Henbury Parish Council – Objection to Planning Applications 17/4034M, 17/4277M, 18/0294M

This document has been produced to respond to the additional documents submitted by the developers relating to cumulative impacts on Air Quality and Traffic.

August 2018

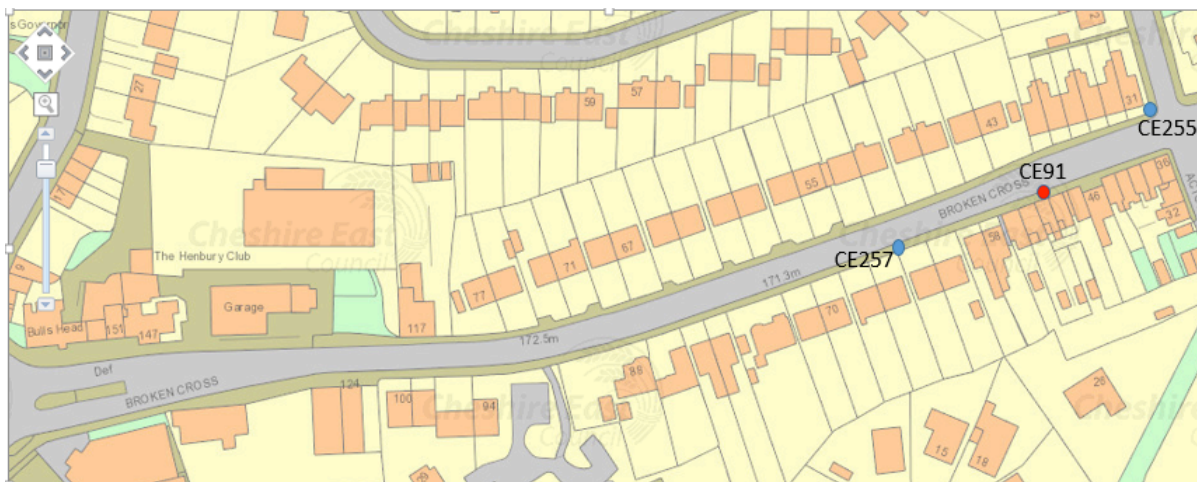
BWB have used receptor R17 at the approximate location of CE91. The modelled NO₂ value is shown to be **21.35** µg/m³ for 2017, and 17.89 µg/m³ for 2020 (without development). The actual 2016 annual reading for CE91 was **47.42** µg/m³, which highlights just how poor the modelling is in relation to this area of high pollution, presumably largely because of the building effects. A map of the relevant section of road and the tube locations is below:

The removed CE91 tube is in an area that can be considered a street canyon. See the picture below. 36-56 Broken Cross is the row of terraced houses to the right that directly front the pavement.

The replacement tubes, CE257 and CE255, are in slightly more open areas, although still close to this section, where pollution dispersal will remain inhibited. As such, following TG16 guidance, these should be dealt with separately to the remainder of the AQMA. Being at levels above $40 \mu\text{g}/\text{m}^3$ means that any change in level will be treated with a higher priority to increases at levels below this limit, and thus alter the way the applications are perceived. For example, a 2% increase in NO_2 at a level $<30 \mu\text{g}/\text{m}^3$ is classed as a **negligible** impact, but at $>44 \mu\text{g}/\text{m}^3$ (CE91 levels) it would be classed as a **substantial** impact (see Table 3.2 in BWB submission). Such a shift can simply be produced by moving a receptor from a building fronting the road to a location where the property frontage is a few metres from the road, and distance-correcting, effectively what has been done in moving from CE91 to CE255/CE257.

HPC therefore argue that monitoring should be reinstated at 36-56 Broken Cross and the AQA for these developments must be made to take account of the results. The modelling simply has taken no account of this key area.
